# Talisman Ltd. (Extension)

Plot # 7-10, 13-16, DEPZ, Ganakbari, Ashulia, Savar, Dhaka-1349.

27 February 2024

## 1. Executive Summary

**Observation-4: Non-structural elements not anchored or braced. (Warehouse Building)**

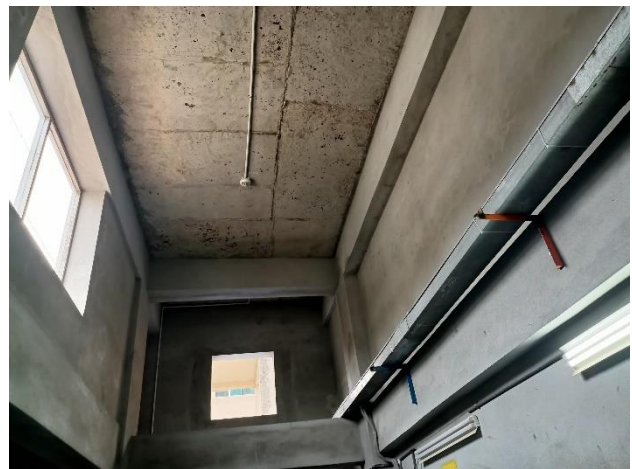
**Description:** Some racks on floors are not anchored or braced to resist lateral (earthquake) forces. The factory is required to anchor/brace all non-structural elements adequately to resist earthquake forces.
